Application No.: 09/874,960

For: LIQUID CRYSTAL DISPLAY AND  
DRIVING METHOD THEREOF

**SUBMISSION OF REPLACEMENT DRAWING SHEETS**

FIG. 7A

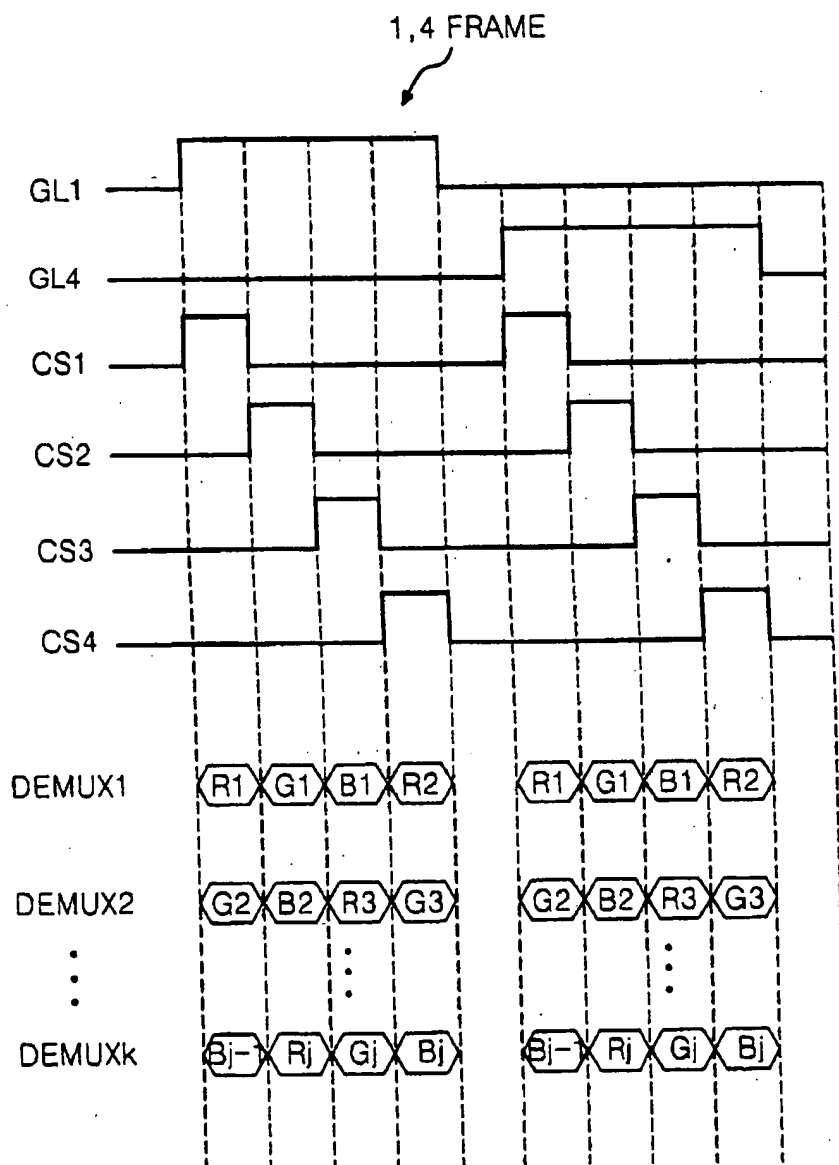
The attached Replacement Drawing Sheets, which include all of the FIGS. 1-7B in this application, replace the previously-filed drawing sheets. In these Replacement Drawing Sheets, FIGS. 7A and 7B have been amended to change "GL2" to --GL4-- in FIG. 7A and to change "GL1" to --GL2 -- and "GL2" to --GL3-- in FIG. 7B, as suggested by the Examiner at page 2, Section 2 of the Office Action dated May 21, 2003, in response to the comments regarding the drawings at Section 2 of page 2 of the Office Action. Moreover, FIG. 21 has been amended to correct a typographical error by changing the second occurrence of "R2" to --R3--.
